Nº 121 SERVICE BULLETIN

SUBJ: Harley-Davidson® Plastic (Butyrate) -15 Support Plate Kit (SPI Nº: 502-5003-67)

Fig. 1

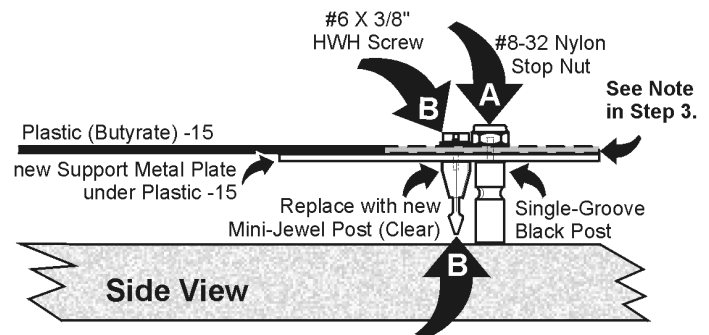
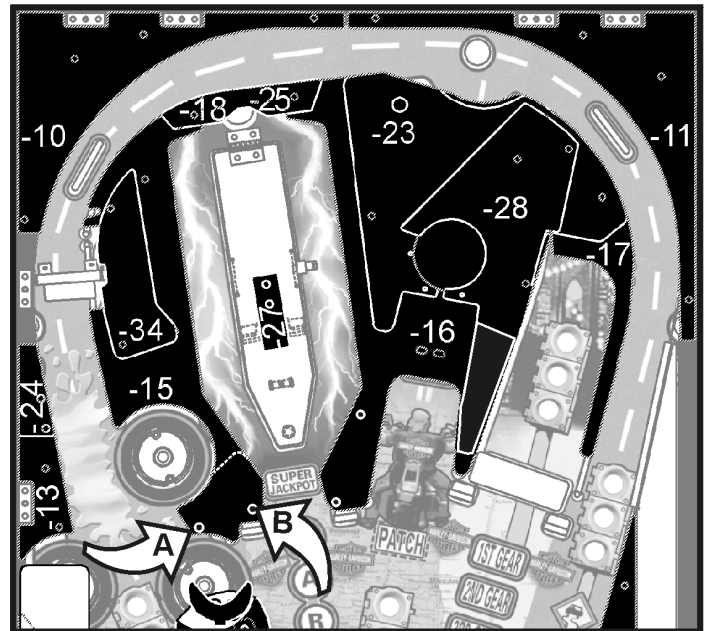
It has come to our attention that some locations where game play is extreme, the Screened Plastic Piece (Butyrate) -15 (located @ the left side of motorcycle) cracks at the front (near the Right Bumper). (See Fig. 1)

We are making a kit available (@cost) through our Distributors which contains the contents listed above (Ask for SPI Part Nº: 502-5003-67). The plate is installed under the Screened Plastic (Butyrate) -15 to prevent it from breaking, if it already hasn't. *Please Note: The individual Screened Plastic (Butyrate) piece is not available; The entire sheet, which contains pieces 01-35, must be ordered...use SPI Nº: 830-5960-XX.*

Step 1: Remove the #8-32 Nylon Stop Nut from the front left hand side of Plastic (Butyrate) -15 mounting location. Remove broken plastic portion (if broken). (See Fig. 1-A)

Step 2: Remove the old Mini-Jewel Post from the plastic (either broken or not) with a 1/4" Nutdriver and discard post. (See Fig. 1-B)

Step 3: Place the Metal Support Plate under the Screened Plastic (Butyrate) -15 or remove the broken plastic portion and place the support plate on mounting screw and then replace broken portion over the support plastic. (Note: Since the support plate isn't screened you will want to keep the broken portion of the screened plastic to use over the support plate for aesthetics only.) Locate the new Mini-Jewel Post [Clear] (The old Mini-Jewel Post which was removed would be stripped, thus the importance of using the new one supplied.) from your kit and install onto the supplied -15 Support Metal Plate Screened Plastic with the supplied #6 X 3/8" HWH Screw with the original Screened Plastic. Next, proceed to locate the #8-32 Nylon Stop Nut you removed earlier and reinstall onto plastic and the support plate with a 5/16" Nutdriver.
